E4980A-02C-S

Safety Service Note

E4980A Precision LCR Meter, 20 Hz to 2 MHz

POSSIBLE "SHOCK PINCH" HAZARD

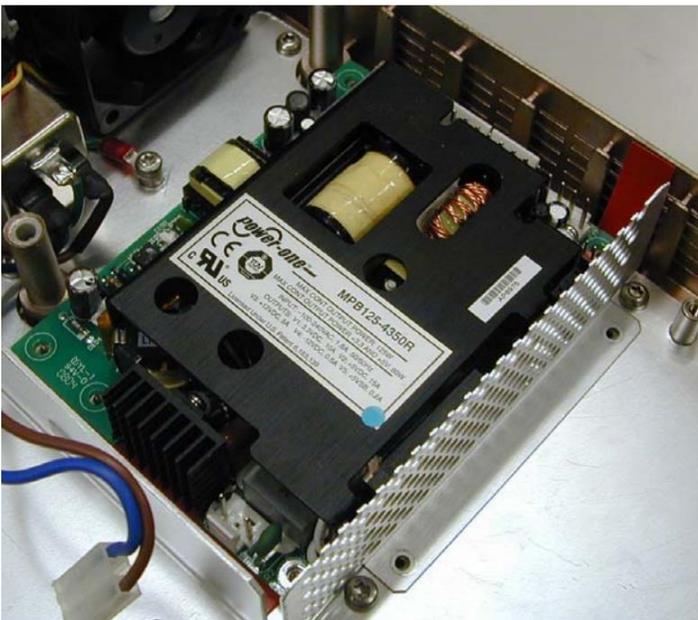
Step2. Put the insulator on base plate as shown in the figure below.

Install an insulator (FILM, p/n E4980-25005) in the E4980A

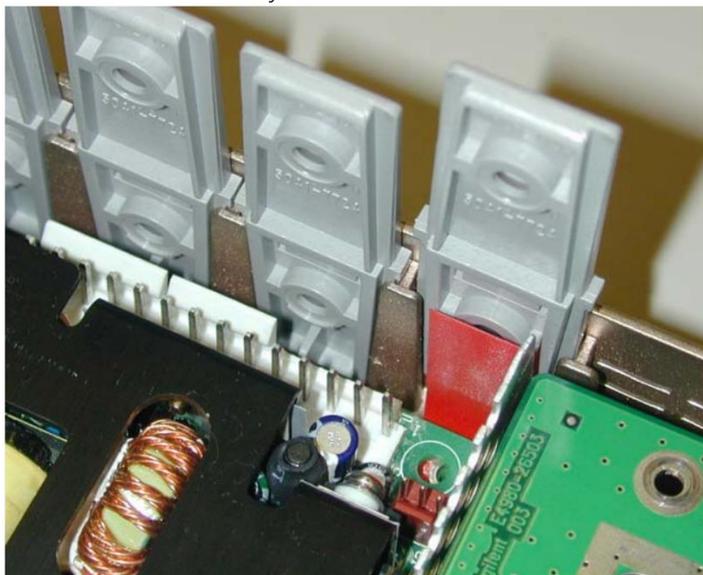
Step4. Reverse the order of the removal procedure. When installing the vent blocks, the confirmation tab of the

insulator is set internally in the vent blocks.

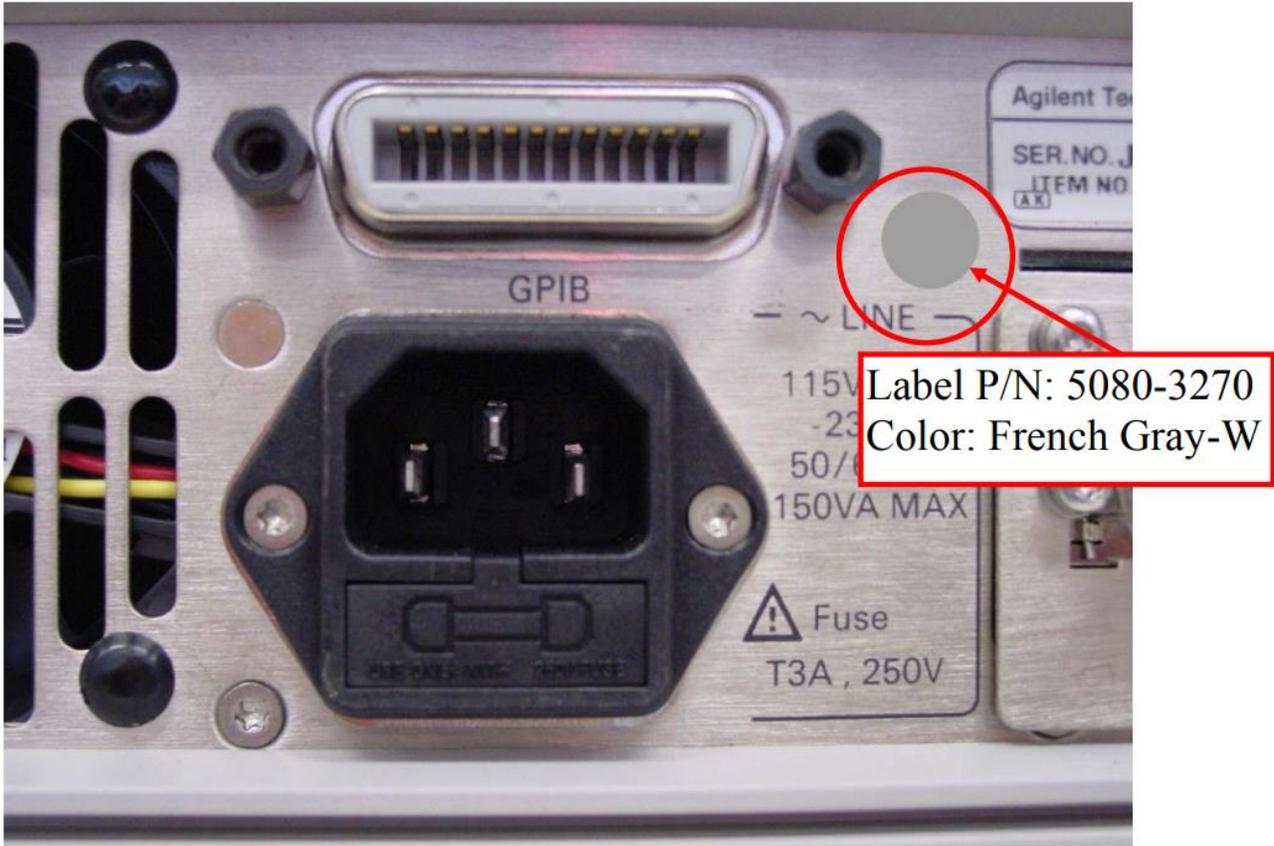
Step8. Stick a label (P/N 5080-3270) between AC Inlet and Serial Number Label. See the place below
